Senior Planner – Major Assessment
City Development Branch
Council of City of Gold Coast

Objection submission COM/2019/81 - Incorrect proposed use of dedicated 'Buffer Land' and
'Permanent trees and shrub screening' areas (Within Lot 467)

Attachment A1 - Lot 467 (the “Extractive Industry Area:” is 70.8 ha

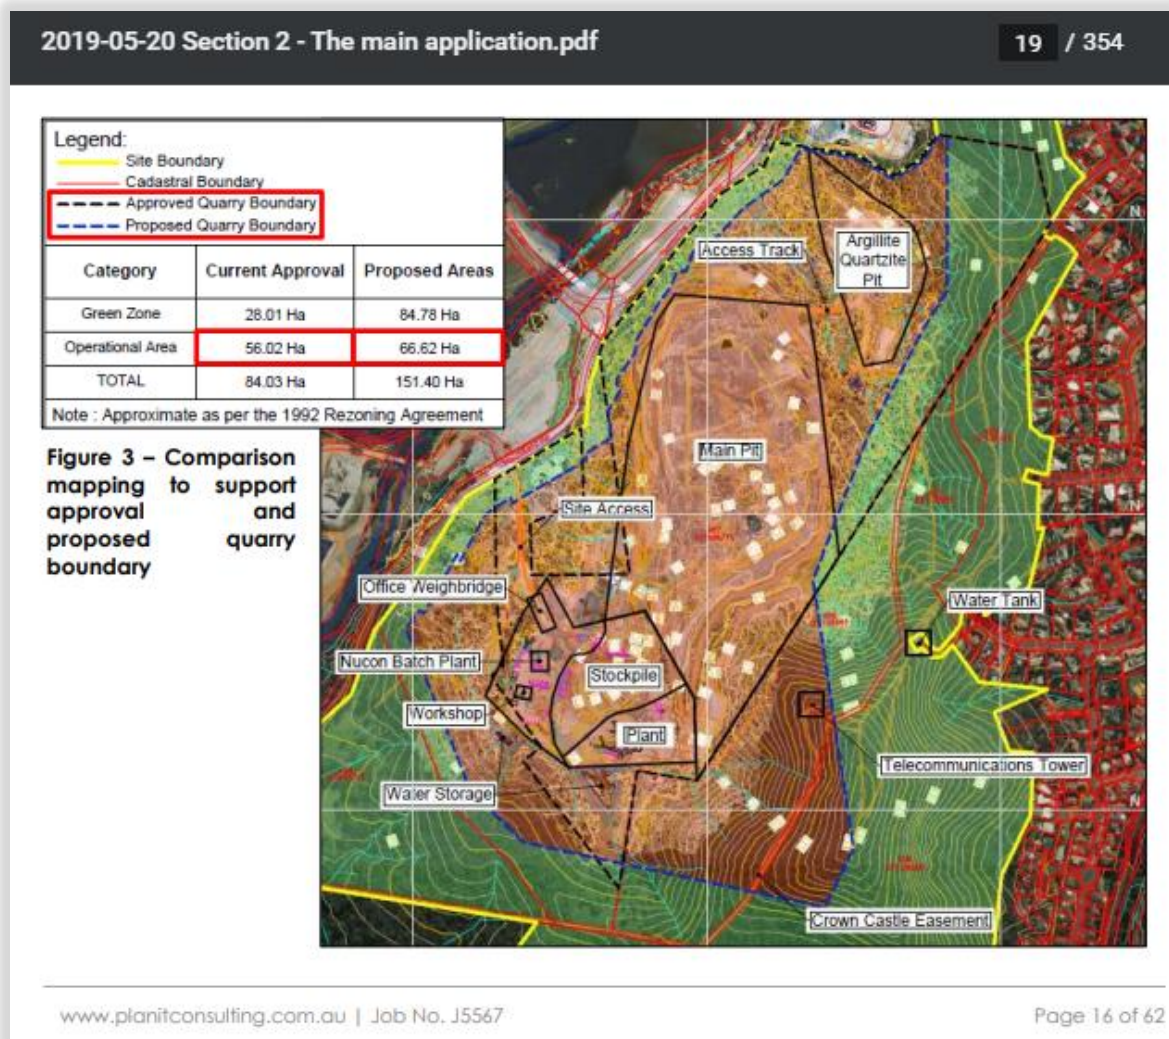
It is noted that the total area of Lot 467 on RP845775, the "Extractive Industry area" is 70.8 hectares in total as defined in the City Plan (Attachment A1).

Attachment A2 - Existing Approval is 56.02 ha (Main Application, Section 2, page 19)

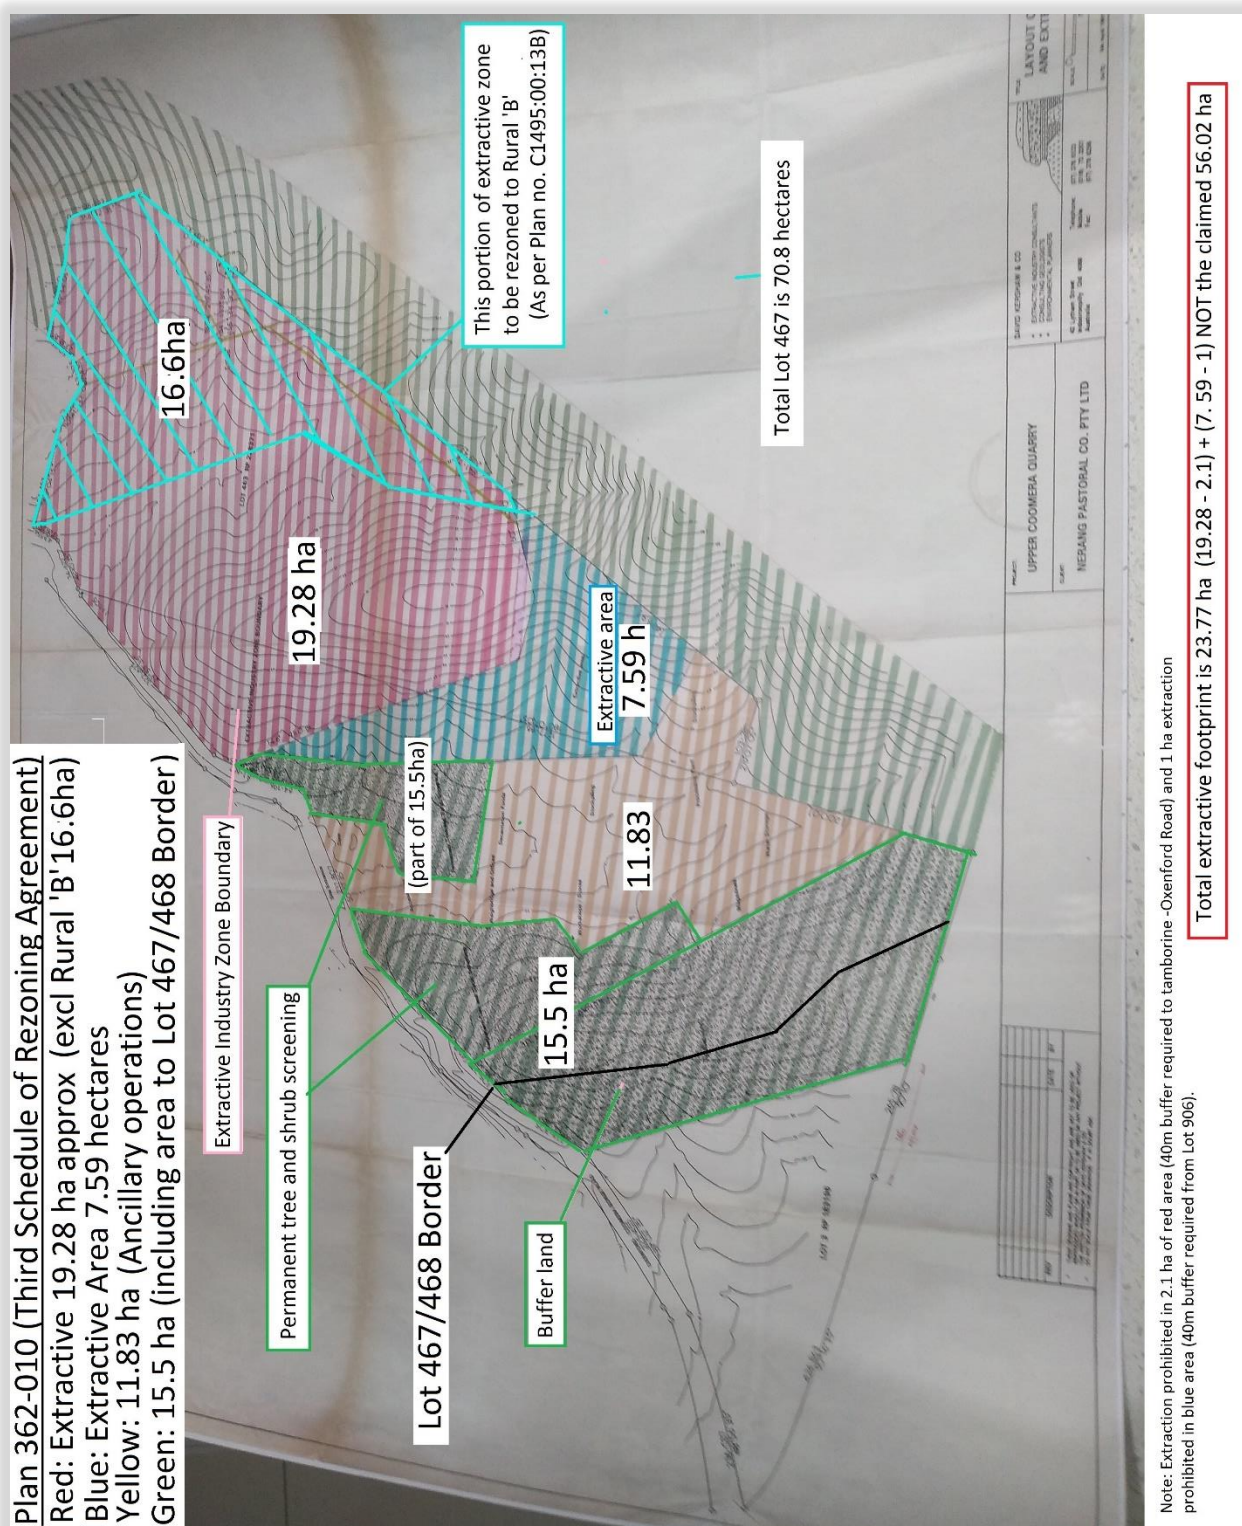
The currently 'claimed' approved operational area, as defined in the development application, is 56.02 hectares (reproduced in Attachment A2). This is verified in the Main application 'Introduction' (Attachment A3).

The difference is 14.78 hectares (70.8 - 56.02). This 14.78 hectares has been negligently and culpably, in my opinion, omitted from the development application due to its defined status of "Buffer Land" and "Permanent trees and shrub screening" as can be seen in the 'Third Schedule' (or Plan 362-010) in the Original Rezoning agreement, reproduced and annotated in Attachment A4).

Attachment A5 - Fourth Schedule of Rezoning agreement altered to seemingly appear as Third Schedule'

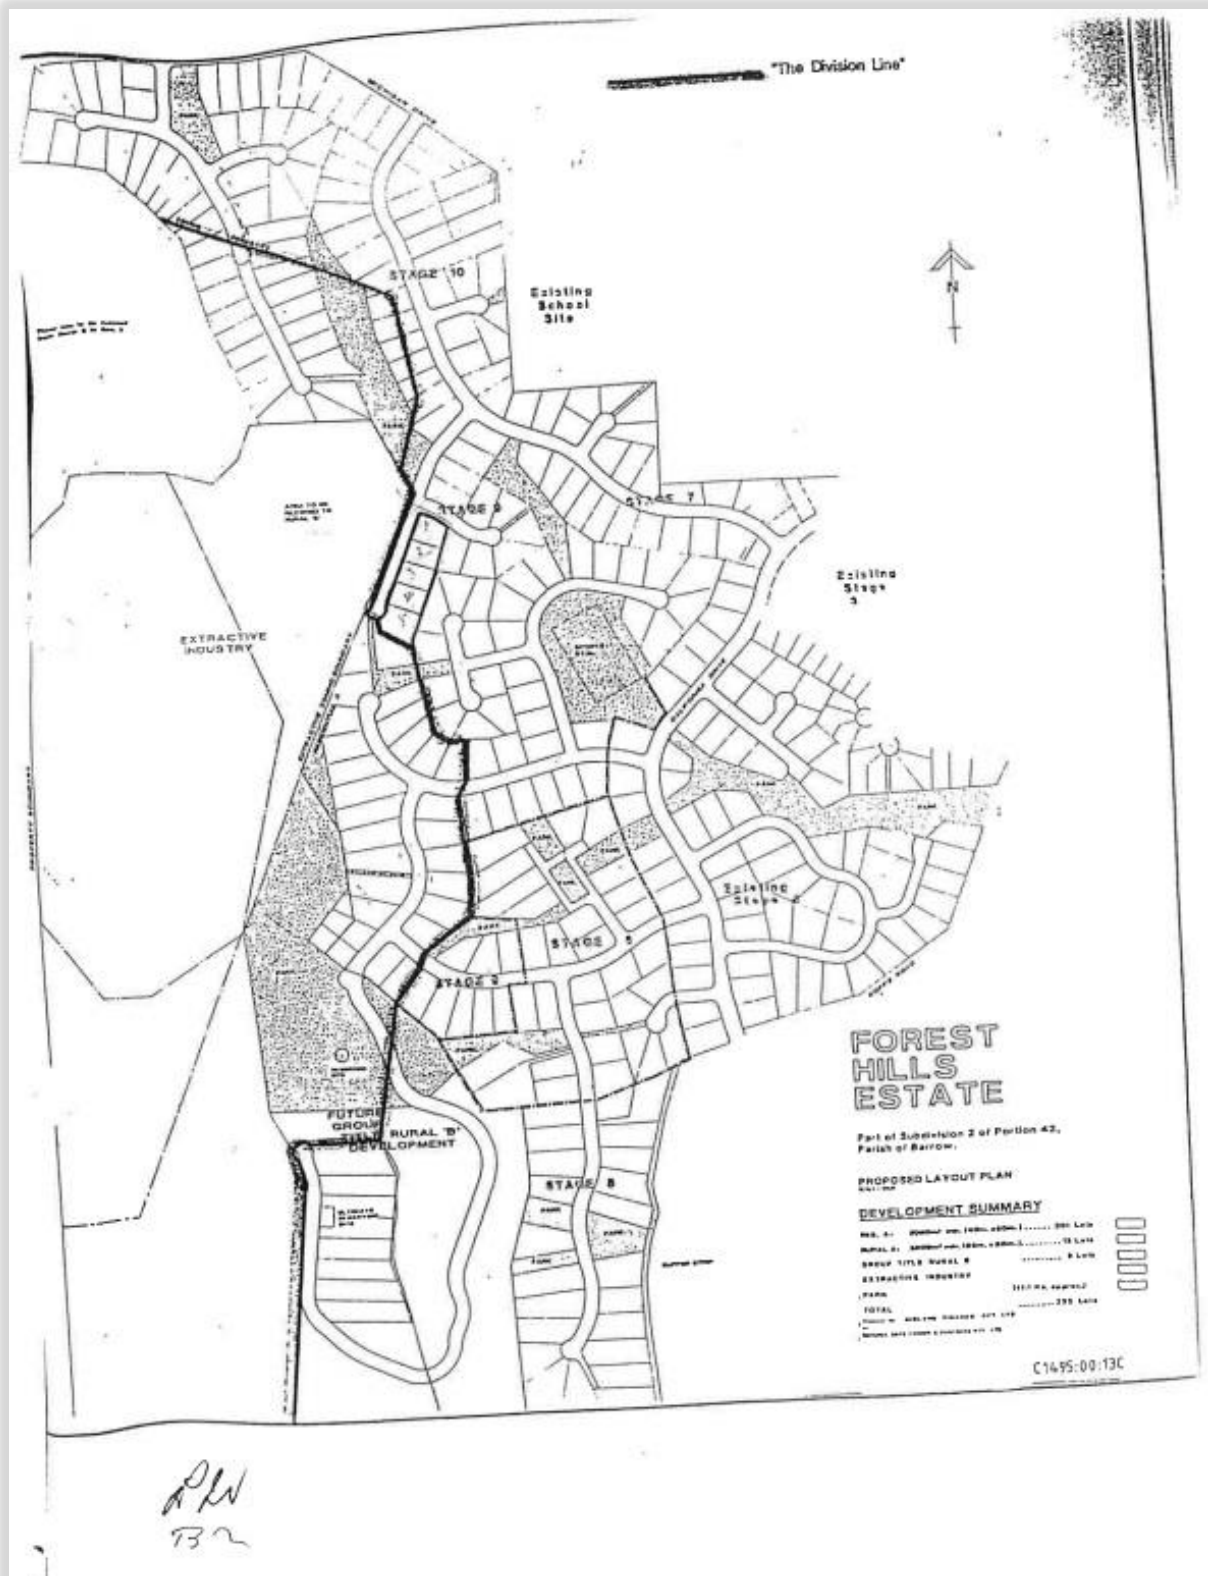
Note the 'Third Schedule' was negligently, in my opinion, omitted from the development application submitted copy of the original rezoning agreement and replaced with a relatively innocuous map that was in fact the Fourth Schedule with the title 'FOURTH SCHEDULE' removed (Attachment A5). The original copy is shown in Attachment A6. This has been discussed in another objection (dated 28th October 2020) so I will not dwell on this other than to say I believe this was a culpable misdirection that placed the Council planners, the SARA Referral team and members of the public at a distinct disadvantage by withholding key information about the current approved buffer status of protected areas that this DA sought, I believe, illegitimately to include as extractive footprint at the time of SARA referral and Public Notification.

Note title "FOURTH SCHEDULE' has been removed. Original shown in Attachment A6 below.

Attachment A7 - Confirmation by Nucrush valuer that the 14.78 ha is "Buffer Areas - Development Prohibited"

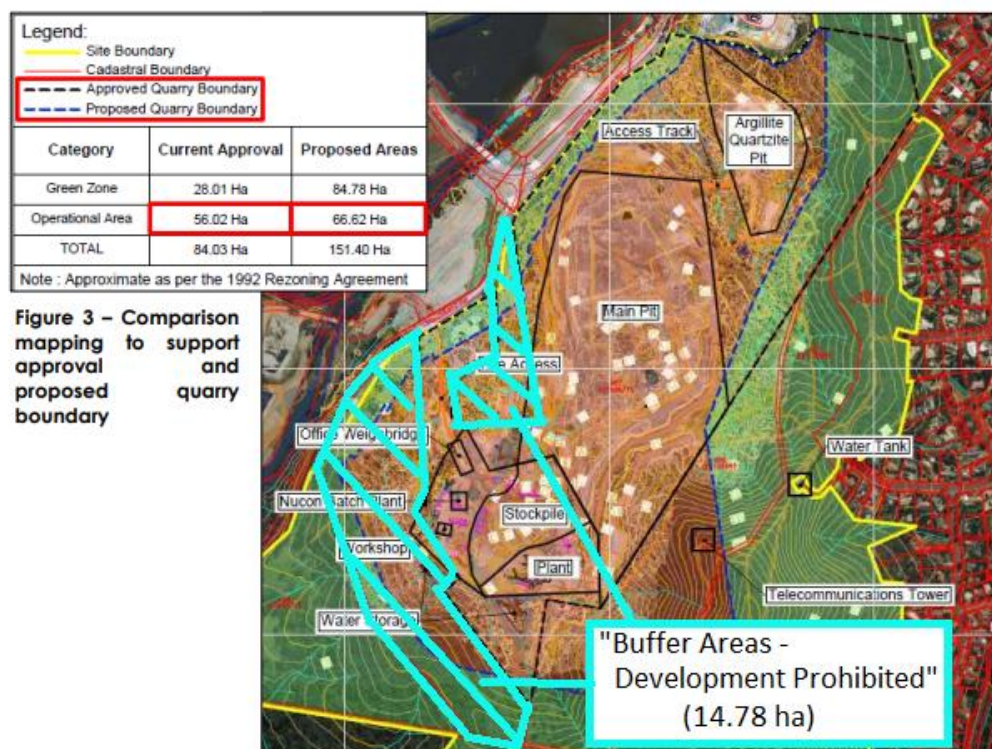
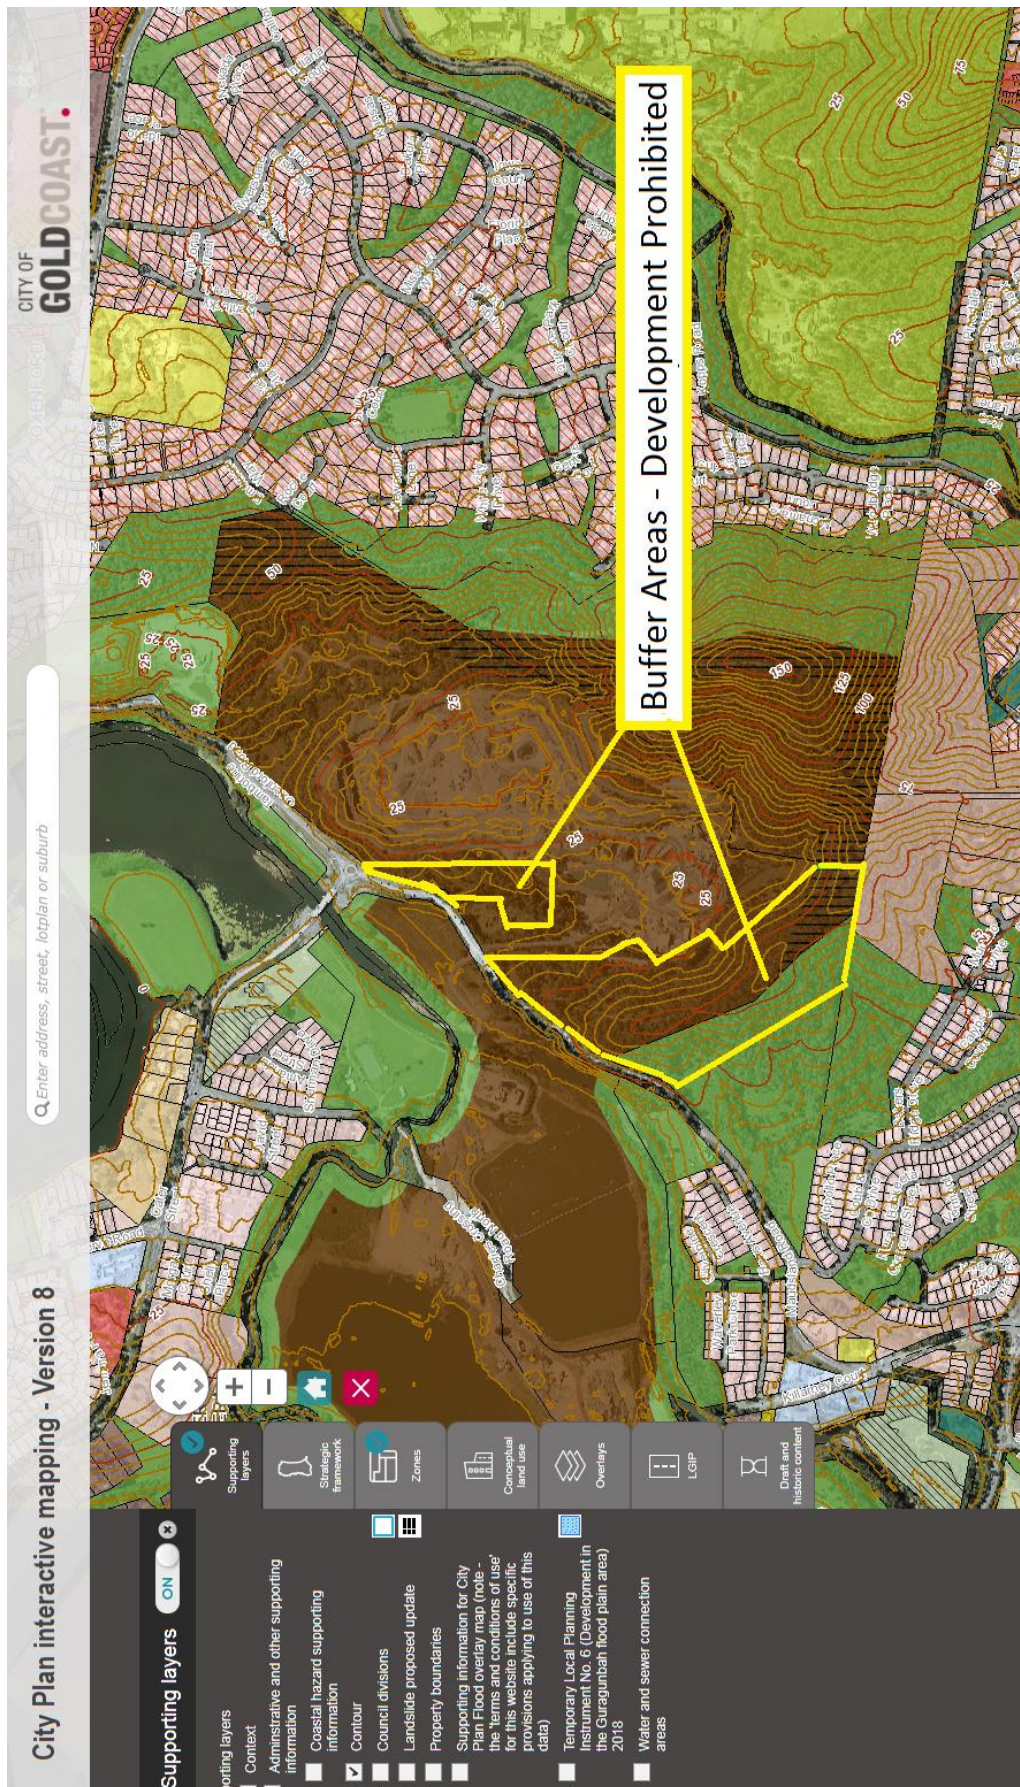
In this case, when discussing the size of the quarry it was quoted by the judge: "Mr Kelaher [the Nucrush valuer] said that there were 45.52 ha classified as "Extractive Industry and Special Uses", 13.23 ha "Rural B", 10.5 ha "Extractive - Development Prohibited" and 14.78 ha as "Buffer Areas - Development Prohibited" (Attachment A7).

From this it is clear to see the omitted 14.78 hectare of Lot 467 is defined as: "Buffer Areas - Development Prohibited". These areas are shown in an annotated diagram in Attachment A8.

Figure 9.3.8-1
 Illustration showing Extractive industry development is located at least 40m away from the top of the ridgeline, as measured horizontally from the ridge peak.

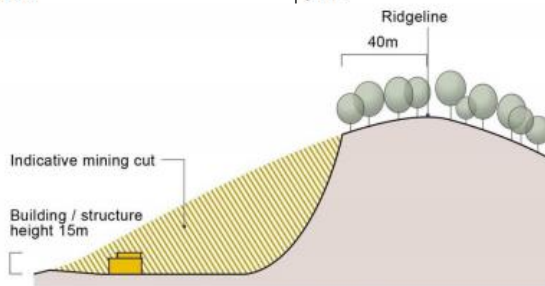
Also, the proposals appear to not comply with Acceptable Outcome AO4 either. Acceptable Outcome AO4 states: *“Development is located at least 40m away from any ridgeline, as measured horizontally from the ridge peak”*. However, by superimposing the contour map, shown in Attachment B1, and the proposed quarry boundary, shown in Attachment A8, it is clear to see the proposed extractive footprint will fail Acceptable Outcome AO4 as the proposed extractive footprint in the southwest corner appears to be at the ridge peak and not *“at least 40m away from any ridgeline, as measured horizontally from the ridge peak”*, as required. However, the applicants reply to Acceptable Outcome AO4: *“Development is located at least 40m away from any ridgeline, as measured horizontally from the ridge peak”* appears to be incorrect again by stating: **“COMPLIES”** (Attachment B2).
